Applicant: EXTRA SPACE STORAGE

Request: BUILDING PERMIT

CERTIFICATE OF APPROPRIATENESS

6-A-24-TOB

C1.1
SITE LAYOUT PLAN
DRAWING

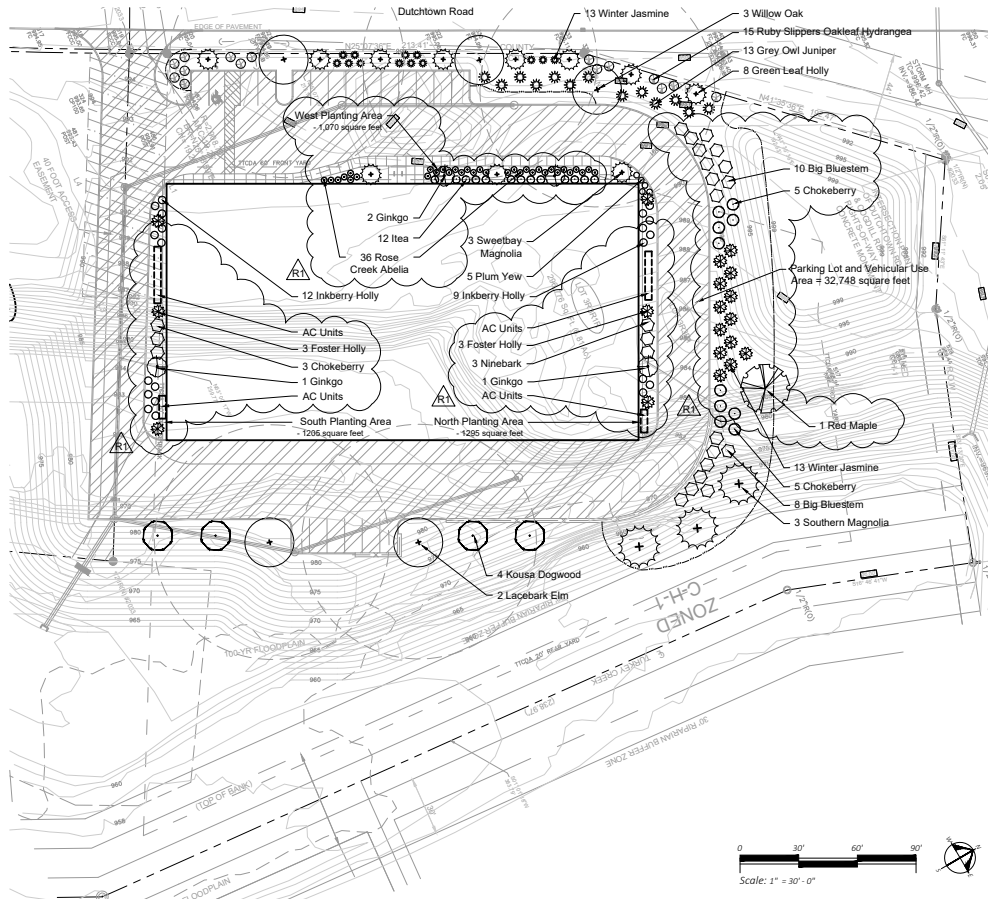
2. Staff supports this waiver as it is a minor reduction of the setback area and still provides a setback distance greater than the 20 ft required by the base zoning of C-H-1 (Highway Commercial). The subject property has an angled corner where the right turn lane of Dutchtown Road approaches Cogdill Road. It is at the point where the property turns that the building encroaches slightly into the setback area; if the front lot line of the property were a straight line, there would be no encroachment and the waiver would not be needed.

3. Site plans show the building encroaching by 3 ft. Staff has proposed a waiver of 5 ft to provide a buffer space.
4. The initial approval for Case 4-B-22-TOB was subject to two conditions, and those still apply. One condition was to increase the floor area ratio from 30% to 31.8% and the other was to

**Waivers and Variances
Requested:** 1. Reduce the front setback requirement when a parking lot is between the building and the street from 60 ft to 55 ft.

1. Approve the waiver to reduce the front setback when a parking lot is between the building and the street from 60 ft to 55 ft since it is a minor reduction of the setback area and still provides a setback distance greater than the 20 ft required by the base zoning of C-H-1 (Highway Commercial), and because if the subject property had a straight front lot line, the encroachment would not occur and the waiver would not be needed.
